Inspection Acceptance and Sign-Off Form

Project Name:	Hope Bay Project
Description of Area Inspected:	Doris North-North Dam Project: 5/8" Aggregate crush capping.
Date of Inspection:	January 20, 2012
Parties Present at Inspection	Mike Price Site Engineer; Nuna Logistics Ltd., John Kurylo EIT; Staff Consultant; SRK Consulting Inc. <i>Ben Vorstermann</i>

NOTES: - SEE JAN 20 th , 2012 CLEANING INSPECTION ACCEPTANCE FORM.		OWNER: NEWMONT NORTH AMERICA Hope Bay Mining Ltd.		PREPARED BY: NUNA Contracting Ltd. 9839 - 31 Avenue Edmonton, AB T6N 1C5		NORTH DAM CONSTRUCTION	
		PROJECT: Doris North Project, Hope Bay, Nunavut		DRAWN BY: RMM		DRAWING TITLE: Cut/Fill Map -Status of 5/8" Excavation to FCM	
				SCALE: 1:250	DATE: Jan. 17 2012	DRAWING NAME (YYMMDD): SM 120117 NORTH DAM 5-8 EXC.dwg

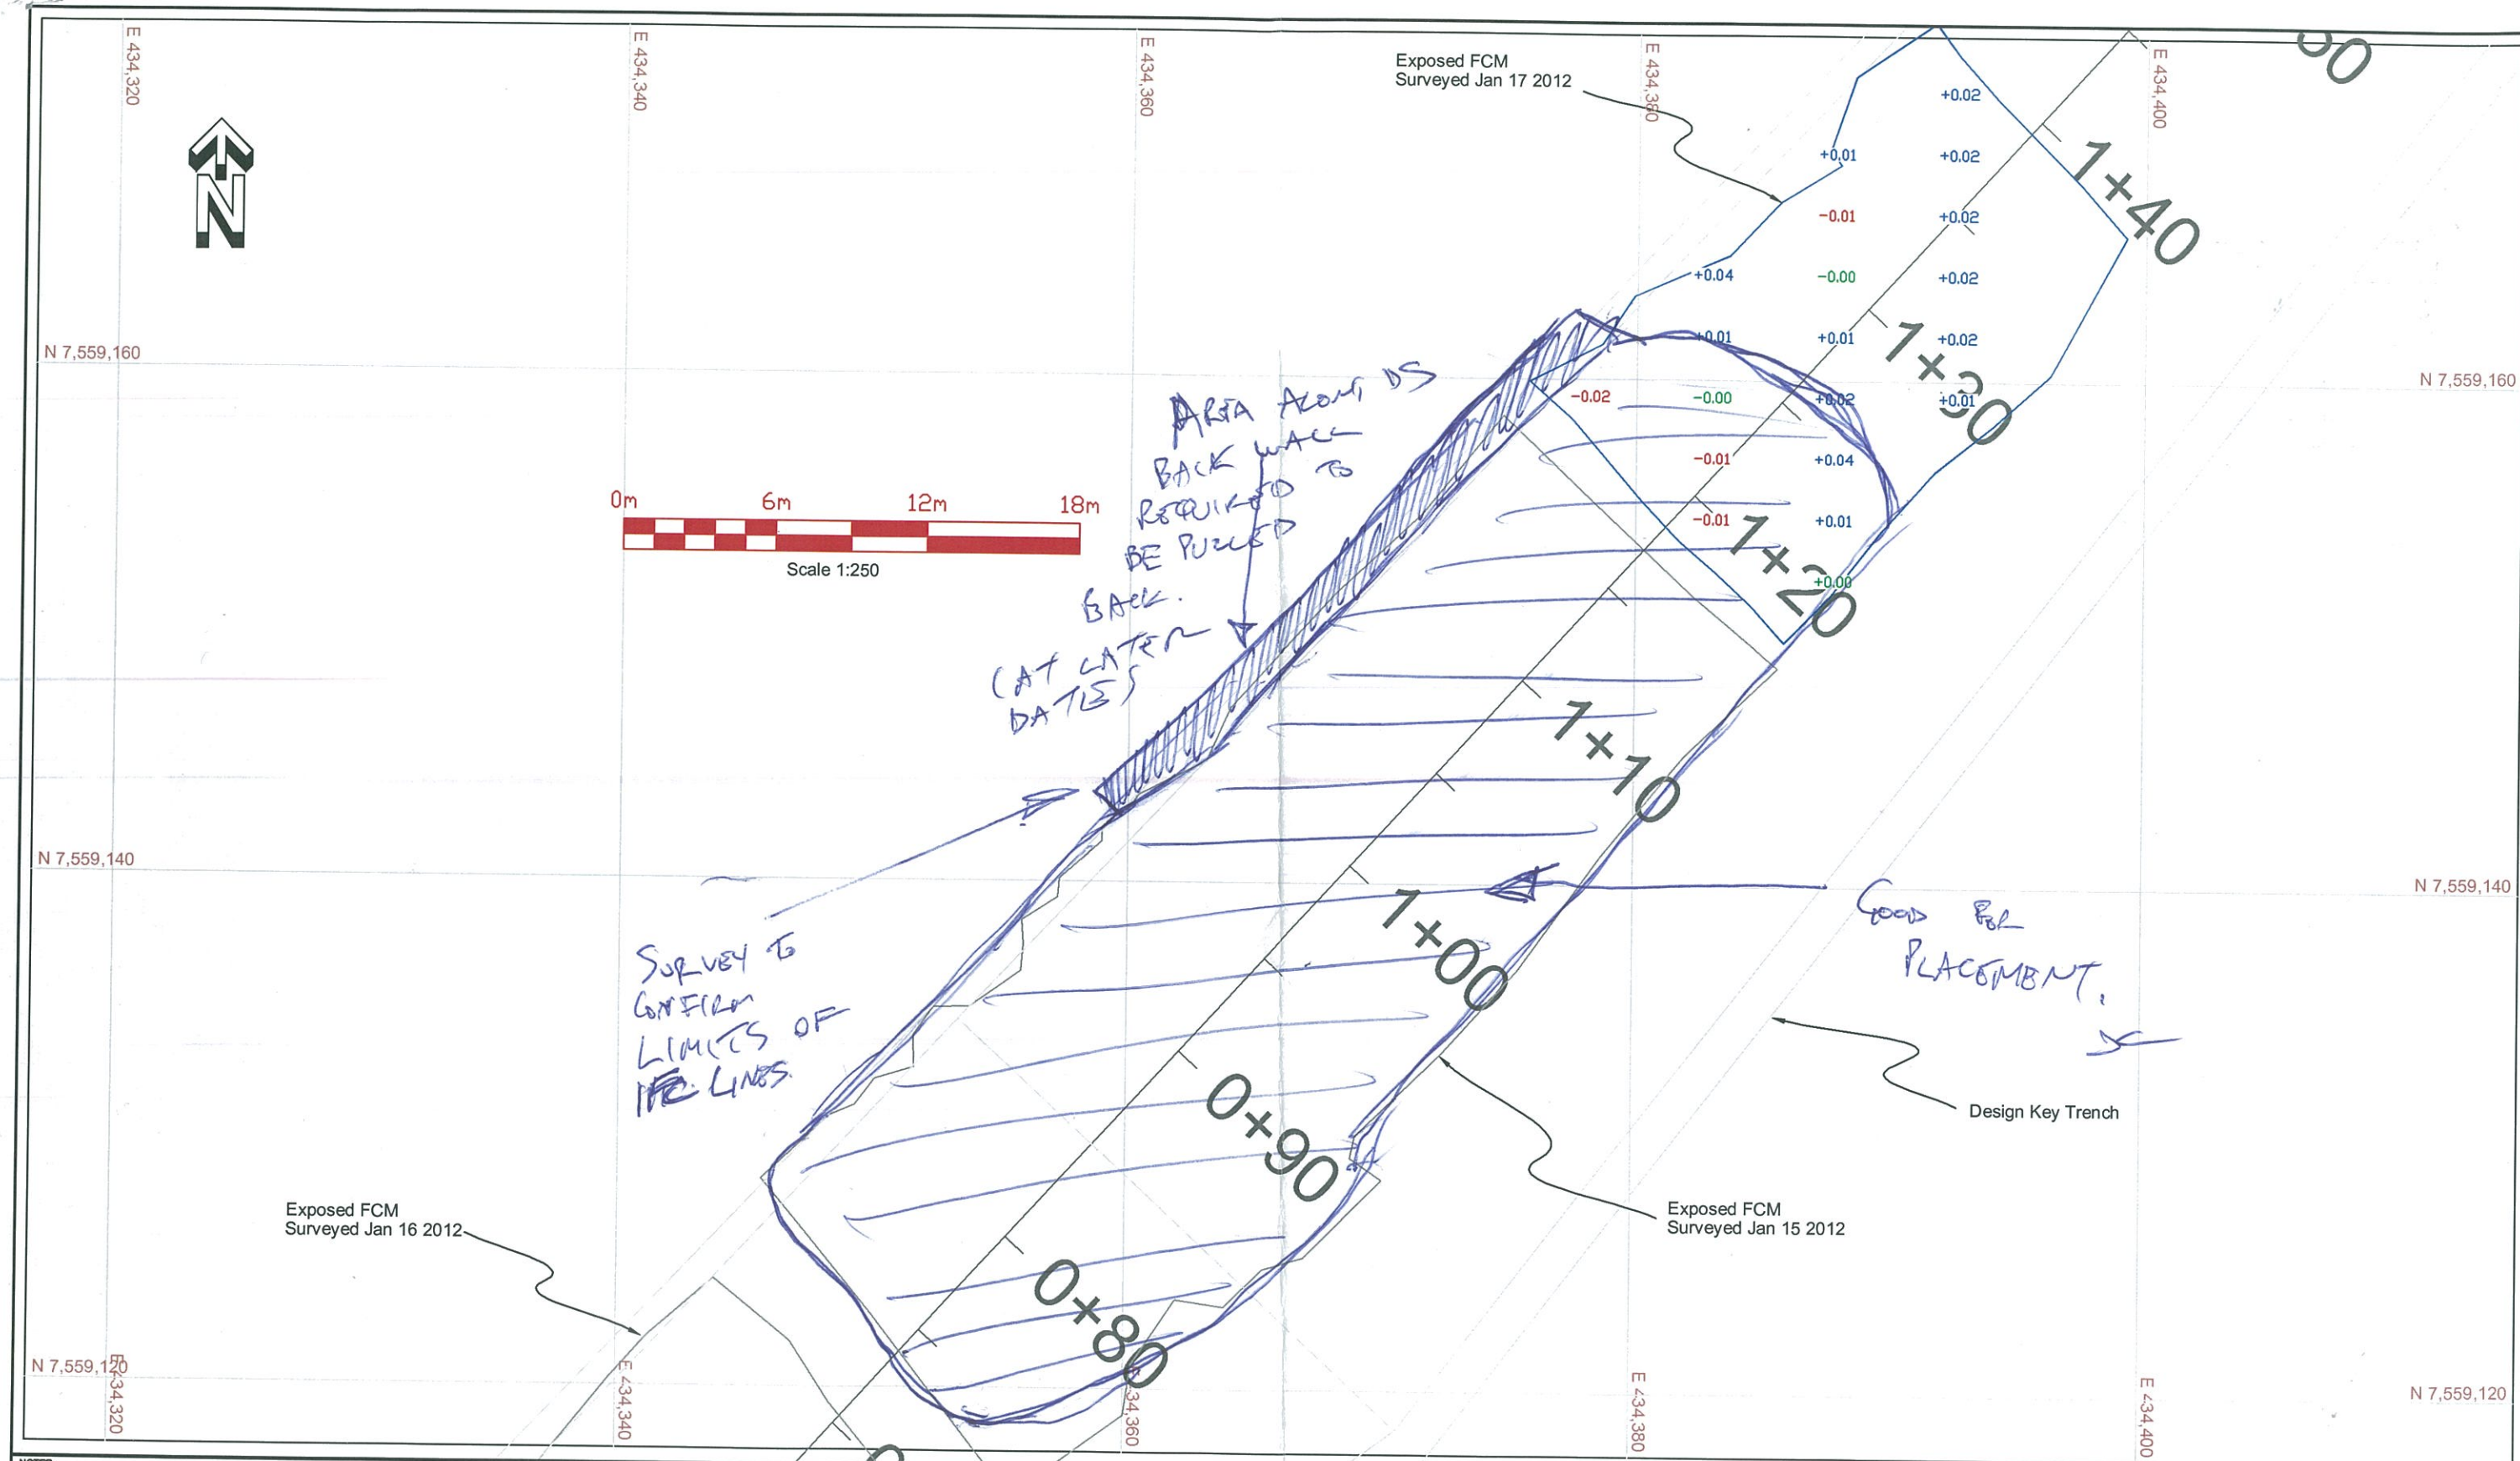
The final remaining 5/8" aggregate crush capping has been removed to engineering's satisfaction to expose the existing North Dan frozen core material placed last year.

*CLEANING OF AREA 5/8" REMOVED APPROVED
FOR PLACEMENT FROM ~ 0+80 TO 1+25.*

*— ADDITIONAL SCRAPING/CLEANING TO DESIGN IFC LINE REQUIRED
IN COMING DAYS - SEE ATTACHED FIG FOR
AREA APPROPRIATE FOR PLACEMENT*

*— CLEANING APPROVAL ONLY VALID TILL END OF
PLACEMENT DAY, THEN MAY NEED TO BE REVISITED / FURTHER CLEANED
(IF SNOW BLOWS IN OVER NIGHT) ETC.*

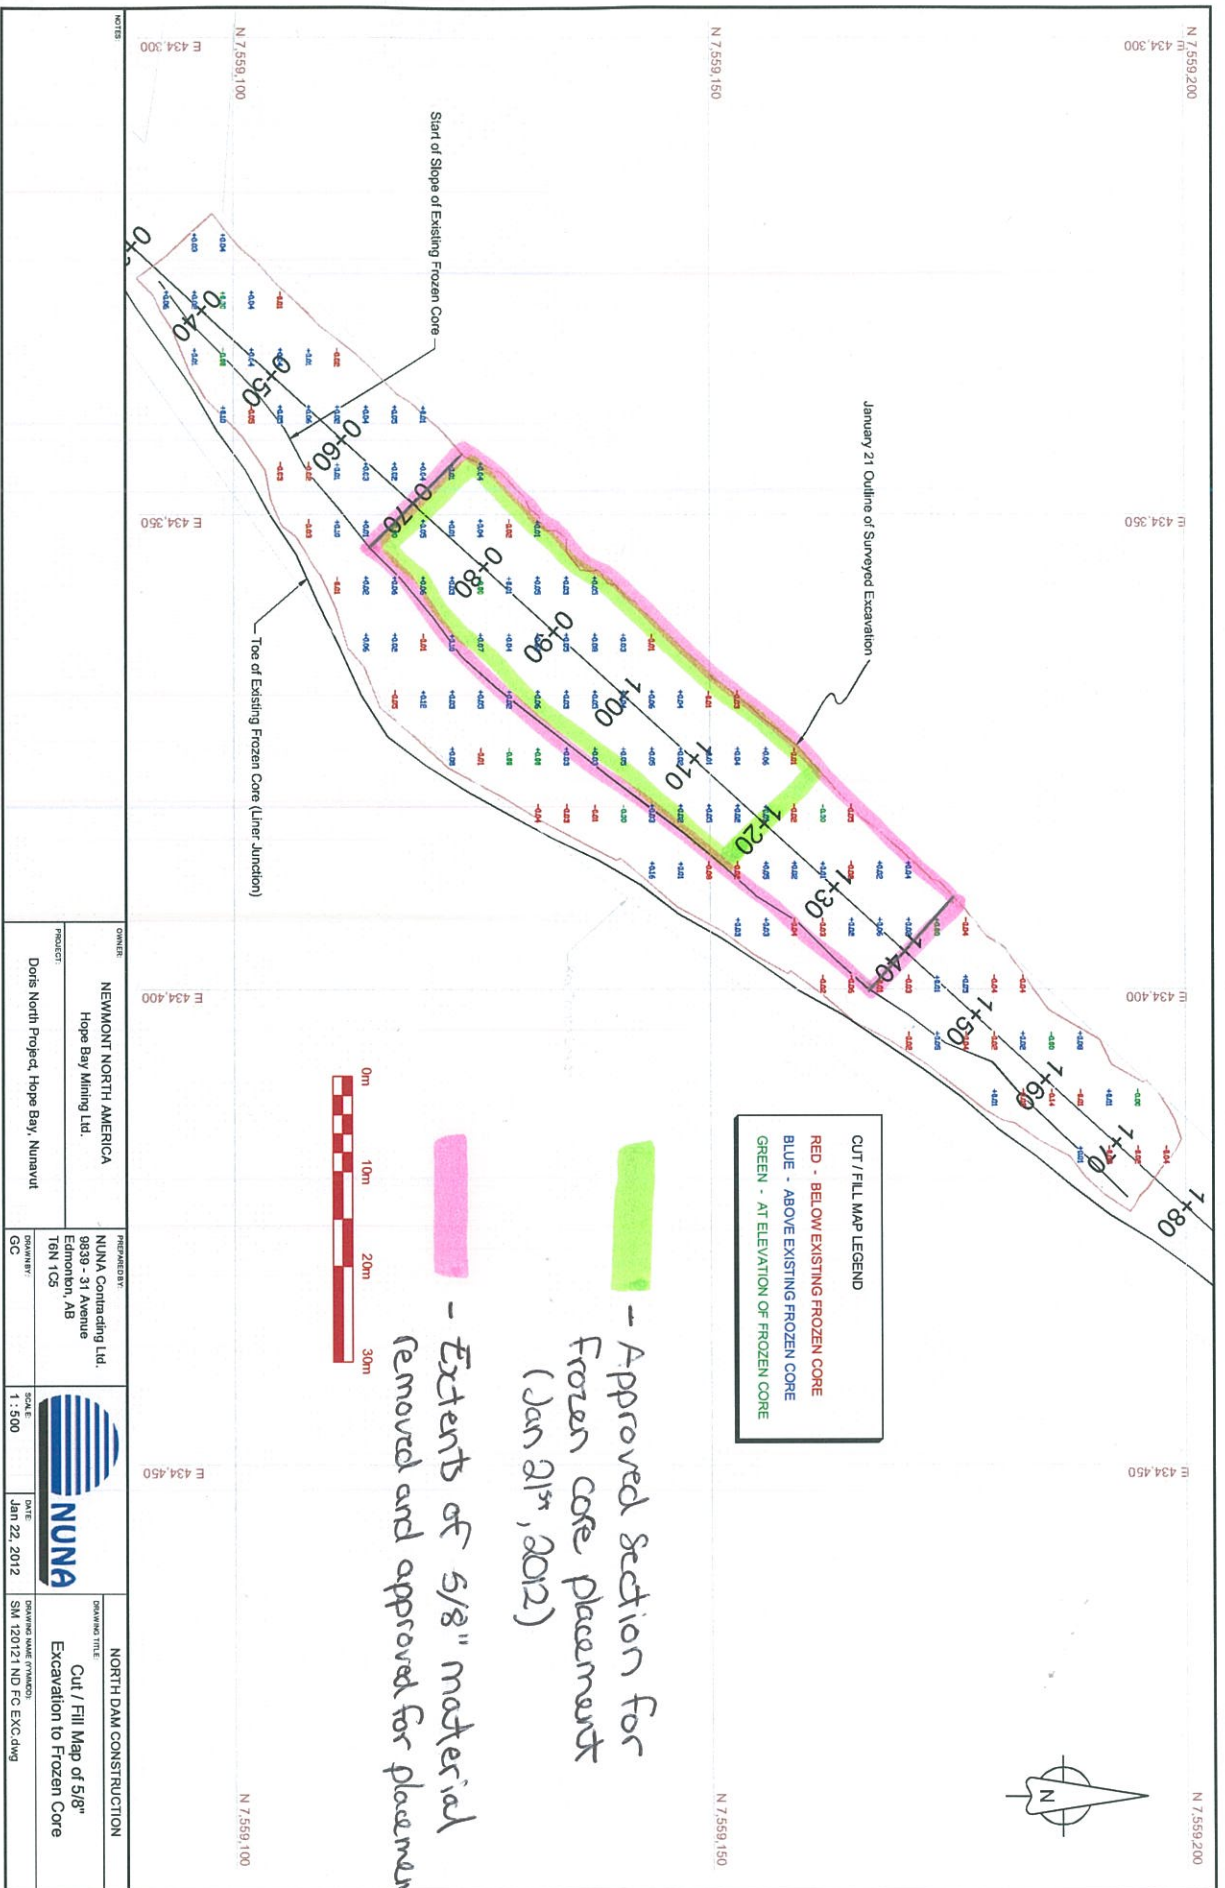
Comments:
<p>1. The 5/8" aggregate crush capping has been removed to the engineering's satisfaction to expose the existing North Dan frozen core material placed last year in the area between 1+24 – 1+40 and 0+70 – 0+74 from the downstream edge to the <u>base</u> of the fillet zone.</p> <p>2. Core placement has been approved for the section of the key trench between station 0+70 and 1+20, from the downstream edge to the base of the fillet slope. This Section meets the engineer's requirements for cleanliness: free of snow, debris and ice build-up, and the previous placed lift has reached the desired temperature "Freezeback" for frozen core lift placement.</p> <p>See appended Survey drawing for details of extent.</p> <p>→ SURVEY TO CONFIRM THAT DOWNSTREAM LIMITS / EDGE HAS BEEN REMOVED</p> <p>Note: Placement approval is based on immediate placement of core product; extended breaks in placement and changing weather conditions may result in additional cleaning.</p>

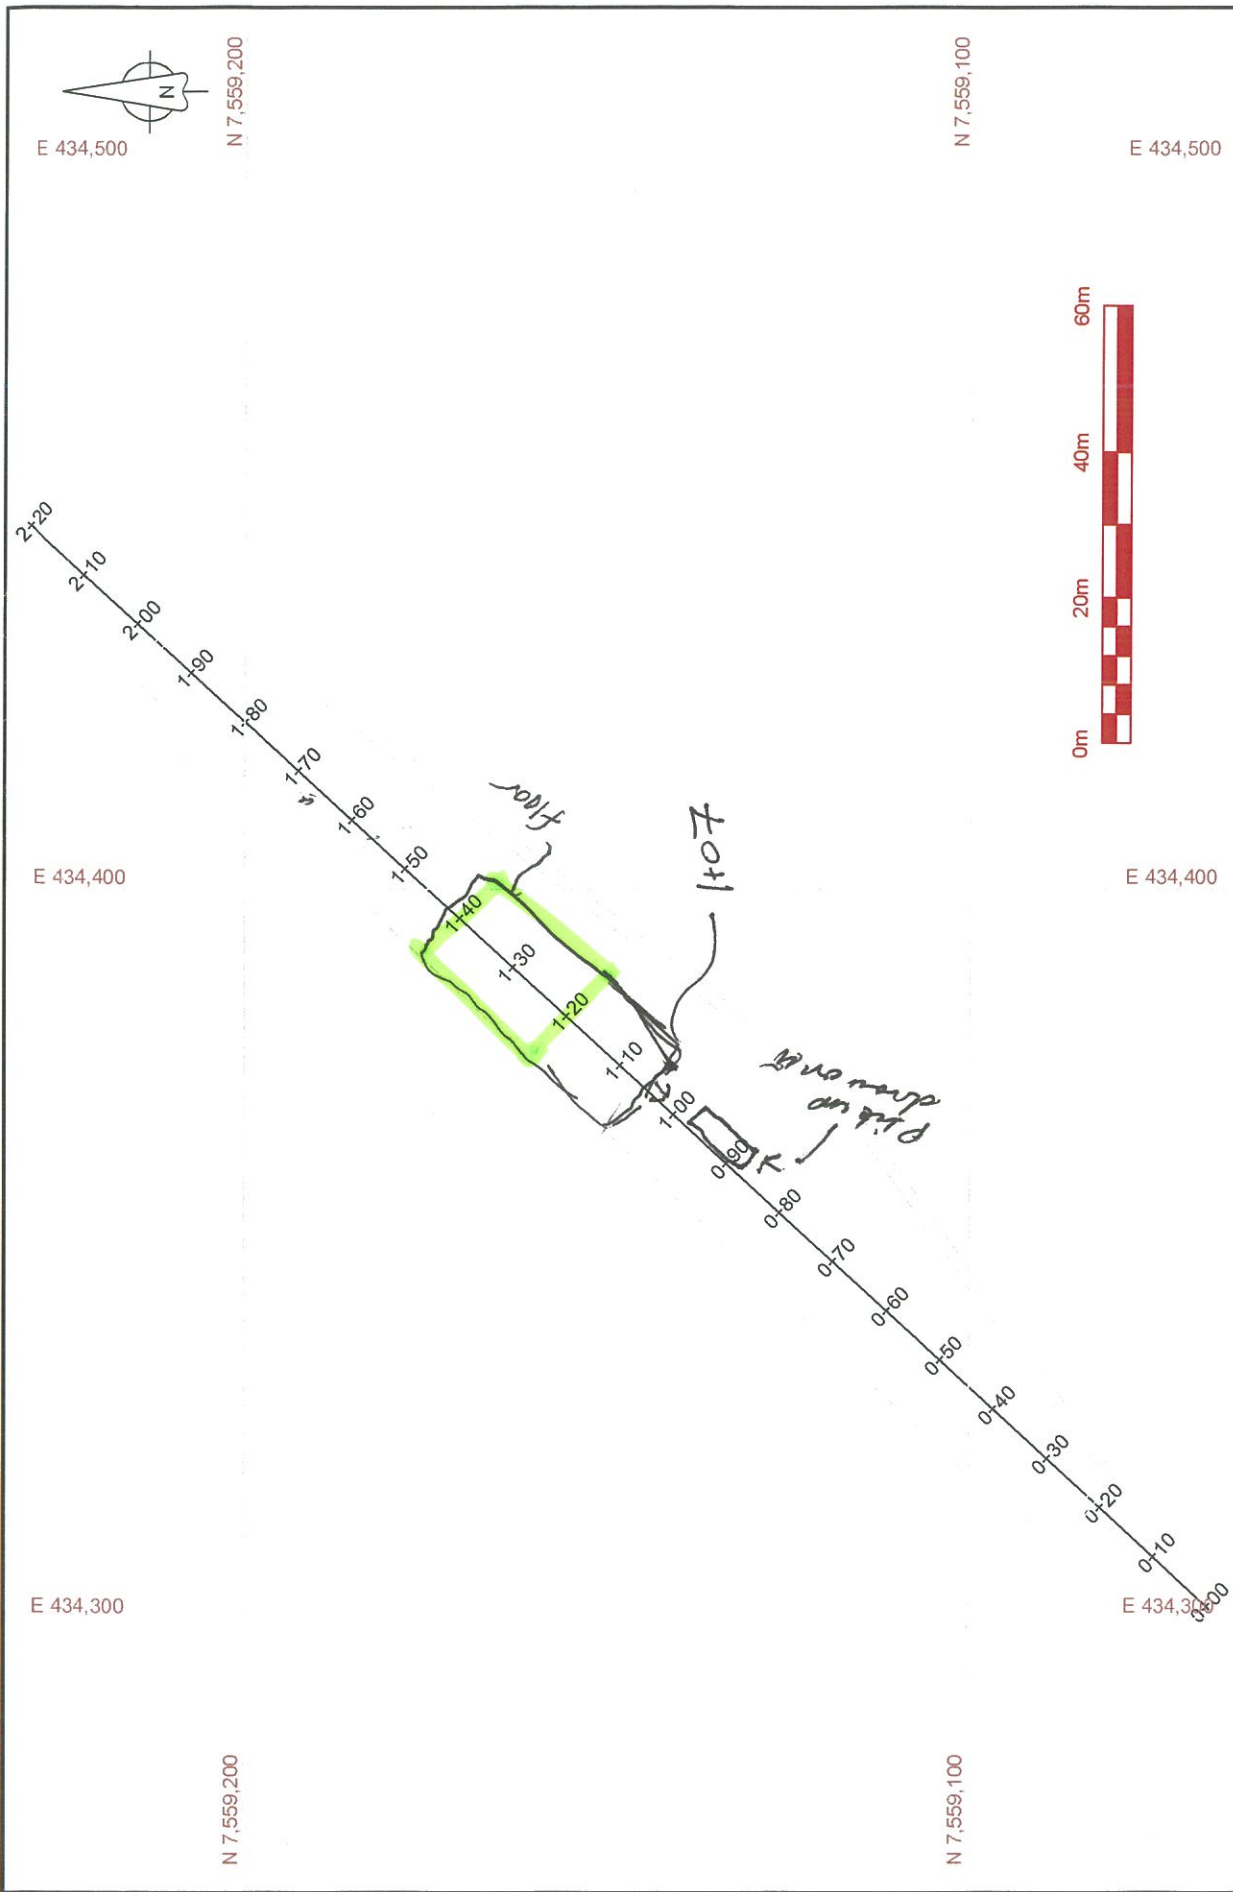
Comments:
<p><i>The designated "Dental cleaned" area has been found to meet the required engineering definition of cleanliness: free of snow, debris and ice build-up, and the previous placed lift has reached the desired temperature "Freezeback" for frozen core lift placement.</i></p> <p><i>Placement has been approved for the section of the key trench between station 1+20 and 1+40, from the downstream edge to the base of the fillet slope.</i></p> <p><i>See appended Survey drawing for details of extent.</i></p> <p>Note: <i>Placement approval is based on immediate placement of core product, extended breaks in placement and changing weather conditions may result in additional cleaning.</i></p>
